SUBJECT: ISSUANCE OF AMENDMENT NO. 182 TO FACILITY OPERATING LICENSE NO. DPR-71 REGARDING THE FUEL CYCLE 11 RELOAD - BRUNSWICK STEAM ELECTRIC PLANT, UNIT 1 (TAC NO. M95263)

AMENDMENT NO. 182 TO FACILITY OPERATING LICENSE NO. DPR-71 - BRUNSWICK, Unit 1

AMENDMENT TO FACILITY OPERATING LICENSE

SAFETY EVALUATION BY THE OFFICE OF NUCLEAR REACTOR REGULATION

FIGURE 3.1.5-1

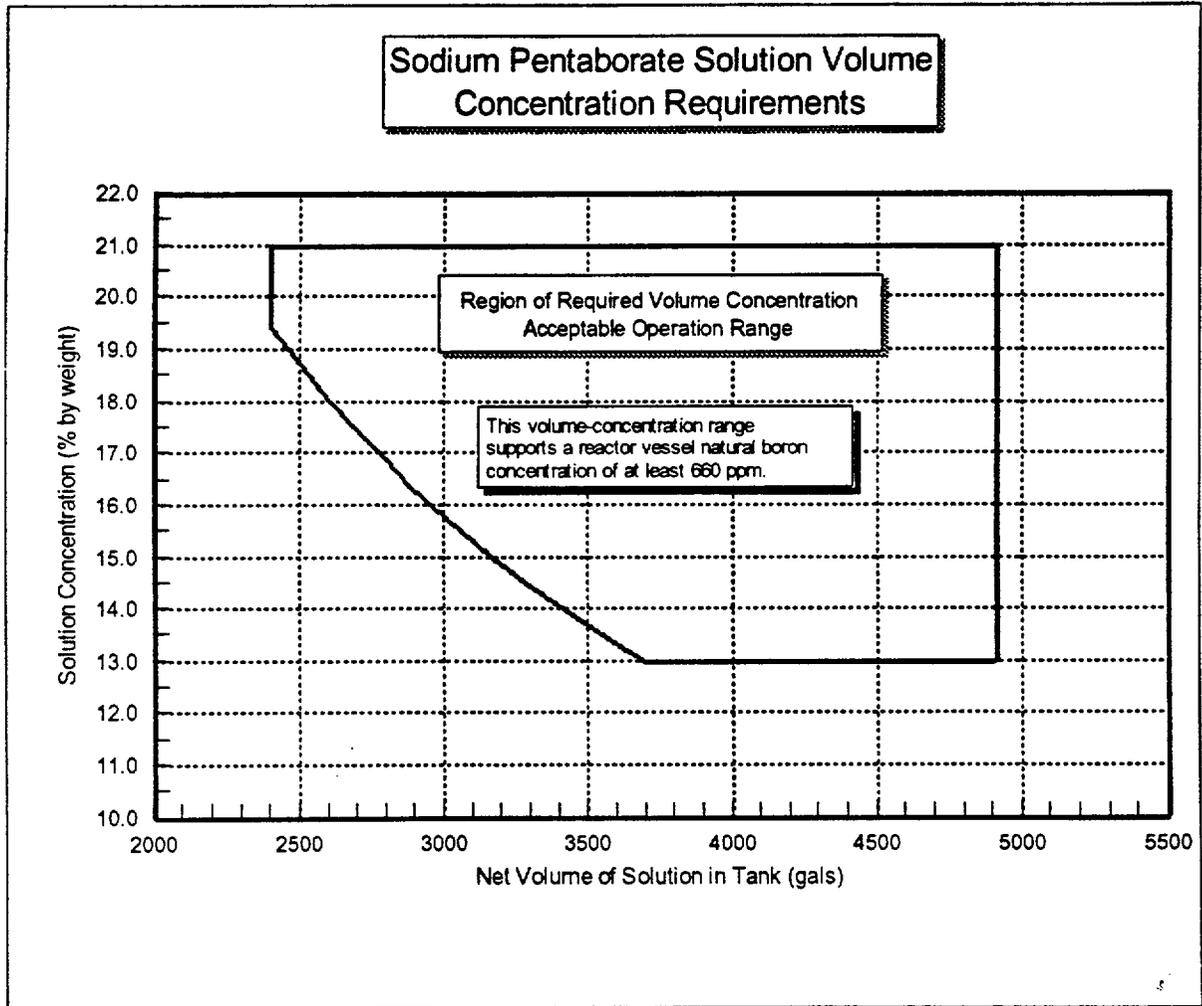
(3) Figure 3.1.5-1

A portion of the SLCS sodium pentaborate volume-concentration range shown in TS Figure 3.1.5-1 (applicable to the lower range of tank volume) is being revised to increase the required concentration of sodium pentaborate solution to account for the additional shutdown reactivity needed based on the planned use of GE13 fuel assemblies as reload for the Unit 1, Cycle 11 reactor core. For the currently approved fuel types, a minimum shutdown margin of 2.6%ΔK is required in the SLCS analysis; and for the GE13 fuel type, GE methodology requires a shutdown margin of greater than 3.2%ΔK. GE calculations show that an in-vessel concentration of 660 ppm boron results in an estimated SLCS shutdown margin of 3.6%ΔK (at 20°C, Xenon free), which exceeds the minimum required shutdown margin of 3.2%ΔK, based on the current minimum SLCS tank concentration of 13% by weight. The proposed increase of the required concentration of sodium pentaborate solution to raise the in-vessel concentration from 600 to 660 ppm boron is acceptable for this plant-specific application, since the proposed concentration results in a higher shutdown margin than the required minimum of 3.2%ΔK. In addition, the previously approved methodologies used in support of this application were documented in a GE submittal (RJR-96-020) dated February 29, 1996.
